Product Update Notification

Dresser™ IMCW2-T+Log with Digital Temperature Probe

May 17, 2023

New Digital Probe (Left) Older Analog Probe (Right)

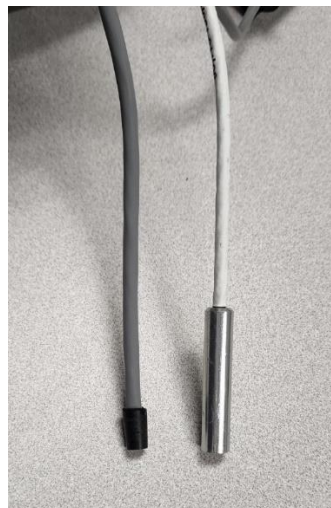
Temperature measurement on the Dresser™ Micro Corrector, Model IMCW2-T+Log has transitioned from analog to digital. With the internally mounted digital temperature probe, the IMCW2 continues to deliver the same highly accurate and stable temperature measurement our customers have come to expect from this product. The photo below shows the different look of the new digital temperature probe versus the analog sensor.

- The internally mounted digital temperature probe will have a new part number – that is Dresser Part Number 062929-010.

- The Dresser Part Numbers for the Assembly #400 IMCW2-T+Log units and the complete IMCW2-T+Log meters are not changing – they will remain the same as they are currently.
- Because the circuit board has been updated to accommodate digital sensors, the digital probe cannot be retrofitted to IMCW2's that have previously shipped with the analog board/temperature probe.
- We will retain a certain amount of inventory on the older analog probes should a customer require a temperature probe for replacement or repair on an existing analog IMCW2 unit.
